SUBJECT: TECHNICAL SPECIFICATION CHANGES RELATING TO THE EXTENSION OF
CERTAIN MAPLHGR CURVES

Re: Dresden Nuclear Power Station, Unit No. 3

Amendment No. 76
License No. DPR-25

ATTACHMENT TO LICENSE AMENDMENT NO. 76

Figure 3.5-1
(Sheet 2 of 5)

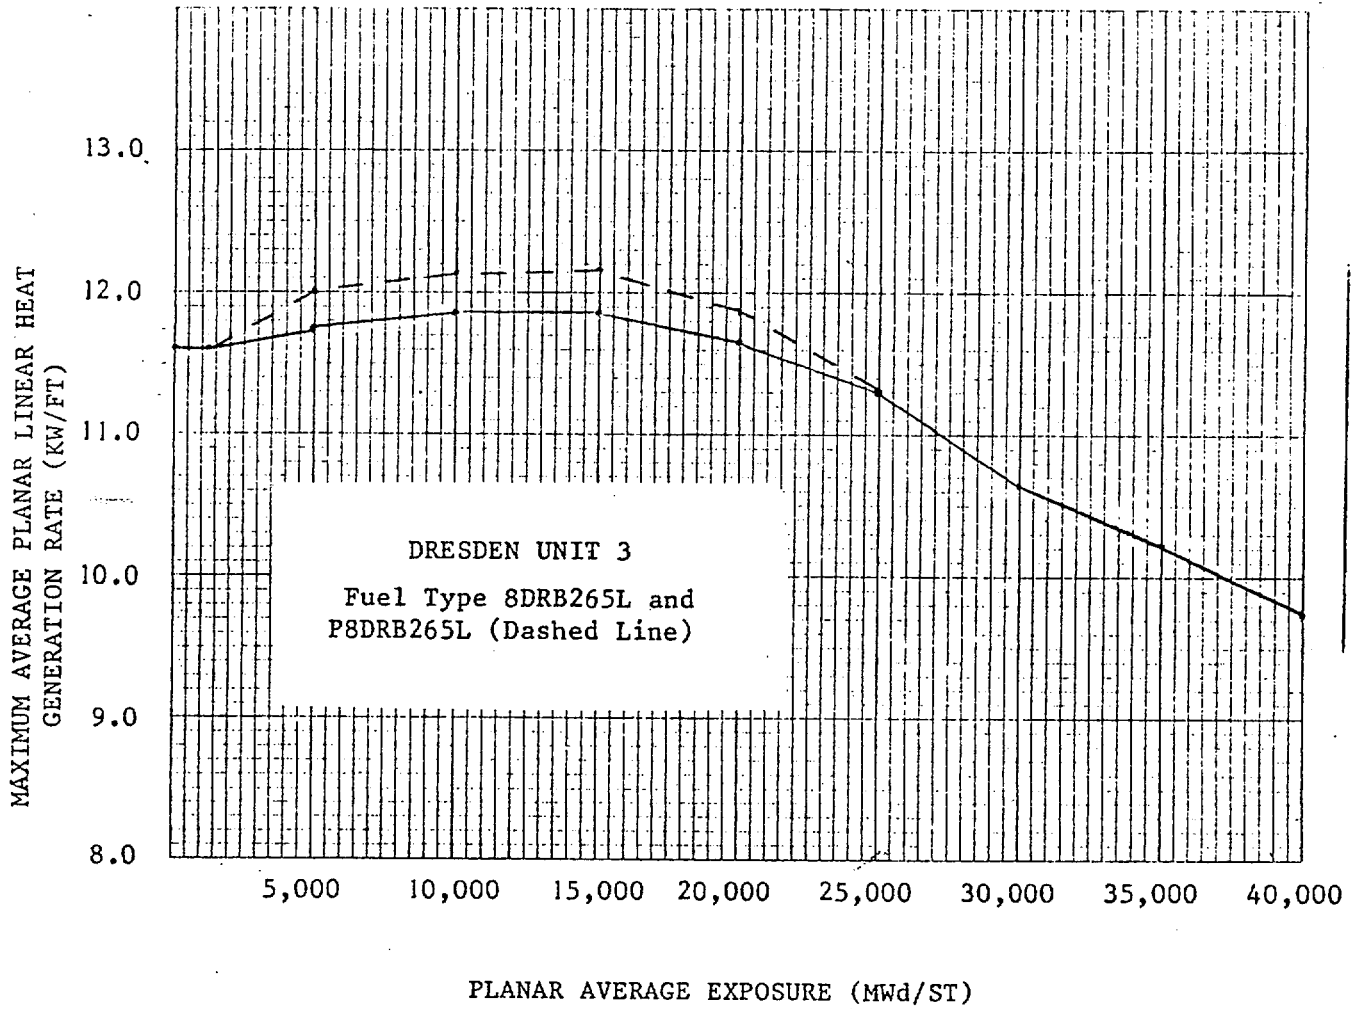
The amendment authorizes an extension of the MAPLHGR limits for residual fuel types 8DRB265L and P8DRB265L in the Dresden 3 core to 40 000 Mwd/STU from 30 000 Mwd/STU. It also approves slightly higher MAPLHGR limits for P8DRB265L in the range 1250-25 000 Mwd/STU.

Revise the Technical Specifications by replacing page 3/4.5-18 with a revised page 3/4.5-18.

The licensee's submittals provided MAPLHGR limits for resident fuel types 8DRB265L and P8DRB265L in the Dresden Unit 3 core. The submittals proposed extension of the limits to 40 000 MWd/STU from the presently approved limit of 30 000 MWd/STU. Although the methodology (Ref. 3) used is generically applicable for the determination of MAPLHGR limits, the staff previously concluded (Ref. 4) that the effects of enhanced fission gas release at high burnups (i.e., greater than 20 000 MWd/STU) were not adequately considered in the analysis. In response to this concern, the fuel vendor (General Electric) requested (Refs. 5-6) that credit for approved, but unapplied, ECCS evaluation model changes and calculated peak cladding temperature margin be used to avoid MAPLHGR penalties at higher burnups. This proposal was found acceptable provided that certain plant-specific analytical considerations were met. These were that (1) no additional credit is taken in the analysis for the ECCS evaluation model changes and (2) the peak cladding temperature for each fuel type and burnup does not exceed that assumed in Table 2 of the Reference 6 letter. The General Electric Standard Application for Reactor Fuel (GESTAR II - Ref. 7) has been modified (Section S.2.5.2.5) to incorporate these considerations.

In addition to the MAPLHGR limit extension, the licensee's submittals requested slightly higher MAPLHGR limits for P8DRB265L fuel in the range 1250-25 000 MWd/STU. Reference 3 provides a licensing basis for this change, which the staff finds acceptable. The change has also been approved previously for Dresden Unit 2 (Ref. 8).
